## SERVICE BULLETIN

**APPLICABILITY:** 2012-16MY Impreza 2.0L Models  
 2015MY-2017MY WRX and STI Models

**SUBJECT:** Rattling Sound from Rear Package Shelf Area

**NUMBER:** 12-189-15R  
**DATE:** 09/23/15  
**REVISED:** 09/22/16

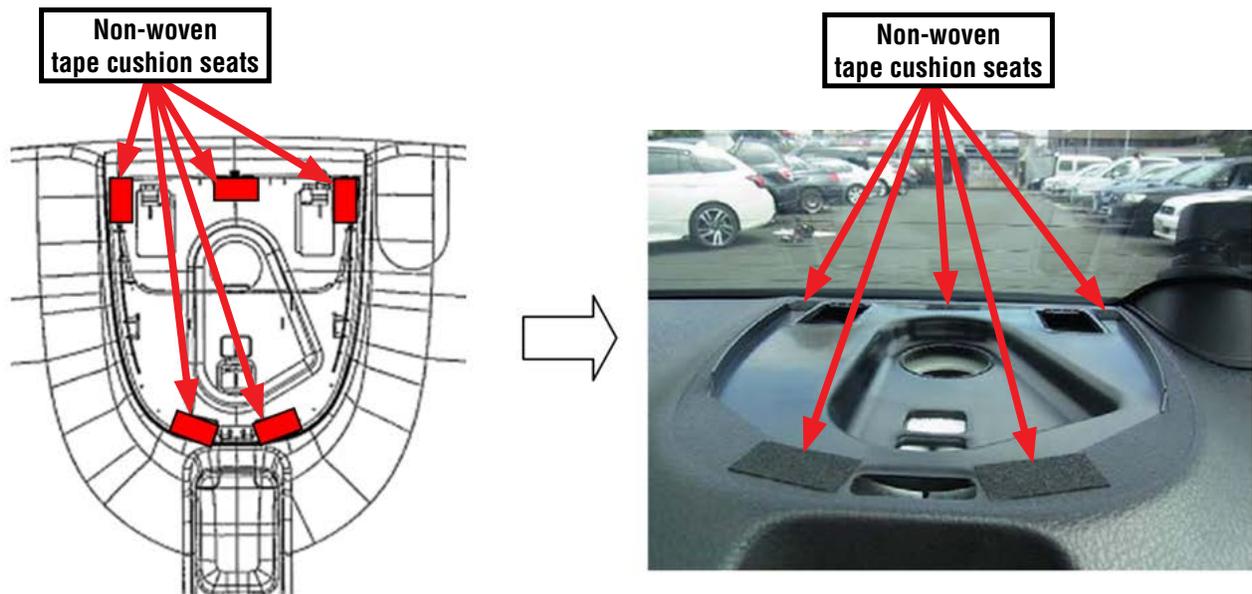
- If the rattle sound is confirmed and determined to be coming from the center stop lamp in the rear package shelf, prepare 5 pieces of non-woven tape material (p.n. **SOA963W110**) 15mm X 30mm. Remove the lamp assembly following the procedure in the applicable Service Manual. Apply the non-woven tape (cushion seats) to the lamp mounting areas of the package shelf as shown in the illustration and photo below. Reinstall the lamp assembly in reverse order of removal.

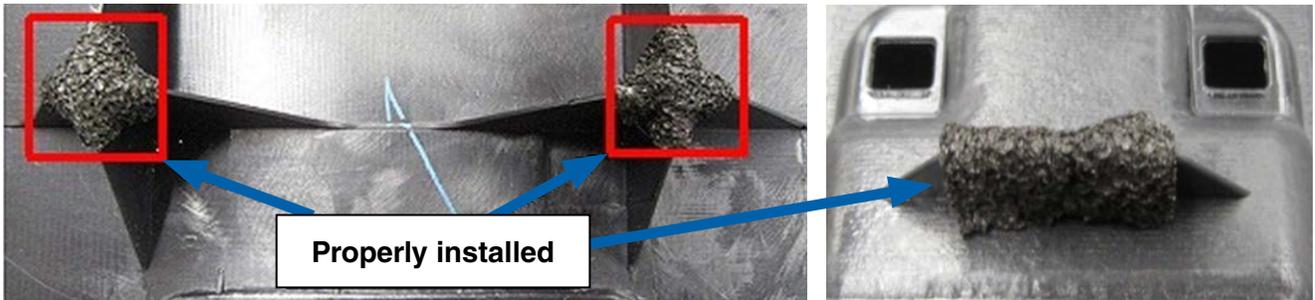
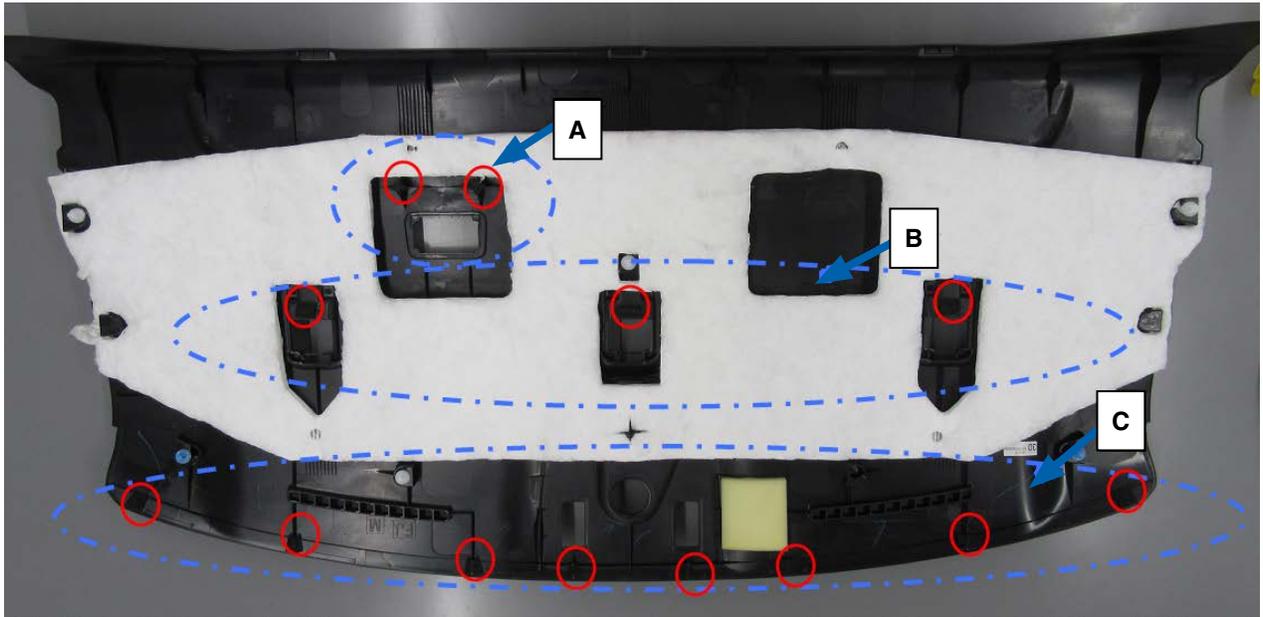
- If the rattle sound is confirmed and determined to be caused by the rear package shelf contacting the rear glass, order a self-adhesive EPT foam tape “kit” (p.n. **63599AJ000**). Remove the package shelf following the procedure in the applicable Service Manual. Using the 3mm X 5mm X 650mm long strips from the kit, apply the EPT foam tape to the rear edge of the package shelf as shown in the illustration below. Each side will use approximately 600mm of the 650mm long strip. In addition, apply the 5 non-woven tape (cushion seats) as referenced above to the center stop lamp mounting areas of the package shelf at this time. Reinstall the package shelf and center stop lamp assembly in reverse order of removal.

- **IMPORTANT:** While the package shelf is removed, always inspect the underside of for missing or misaligned EPT foam tapes which must be applied to the support rib and stand portions. This will insulate the package shelf from the vehicle body. The photo below shows all the locations in areas **A, B & C** (circled in red) which should be inspected and have EPT foam tape applied as needed before reinstalling the package shelf. Example photos of how the EPT foam tape should appear after application are also supplied.
